RELEASE FOR CONSTRUCTION  
AS NOTED FOR PLAN REVIEW  
DEVELOPMENT SERVICES  
LEE'S SUMMIT, MISSOURI  
03/01/2022

Drawing title:  
**The**  
**OAKMONT**  
**Elevation: A**  
Site Description:  
**Lot 97, Summit**  
**View Farms -**  
**4th Plat**  
Street Address:  
**3120 SW Summit**  
**View Tr., Lee's**  
**Summit, Missouri**  
General Contractor:  
**IQ Construction**

Sheet No.:  
**A-1** of 6

FRONT ELEVATION

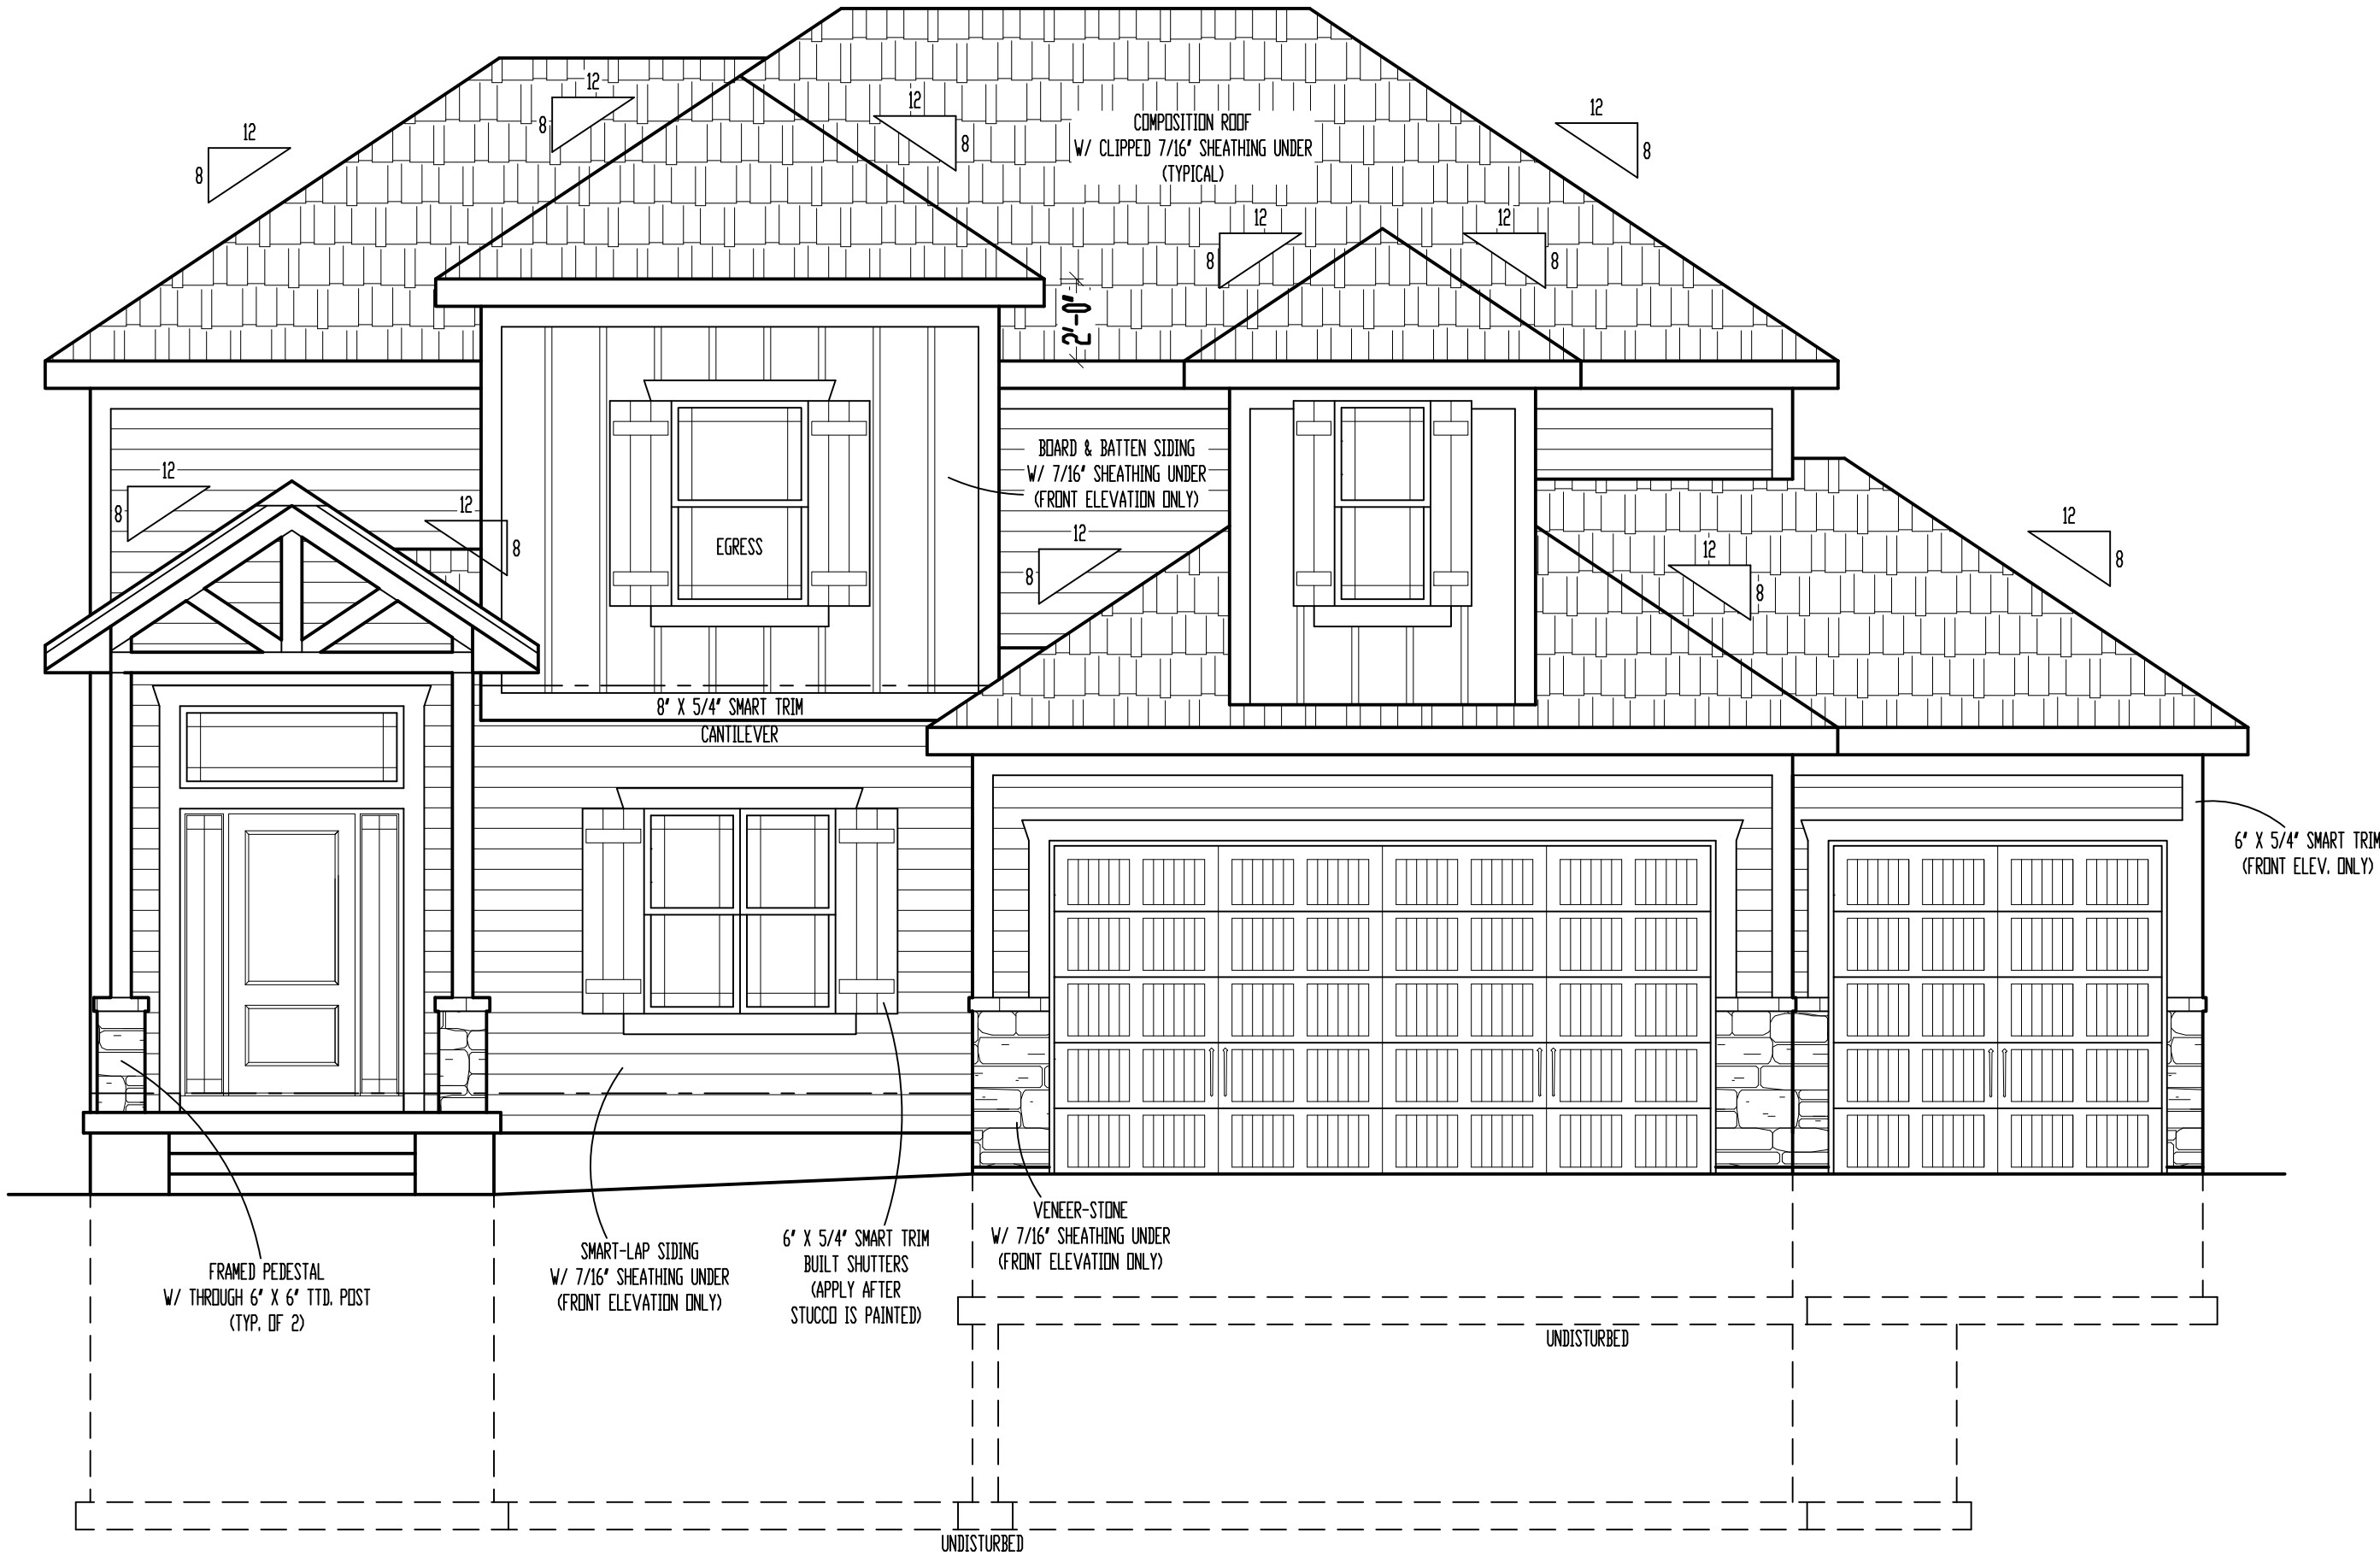
SOILS REPORT NEEDED AT TIME OF FOOTING INSPECTION
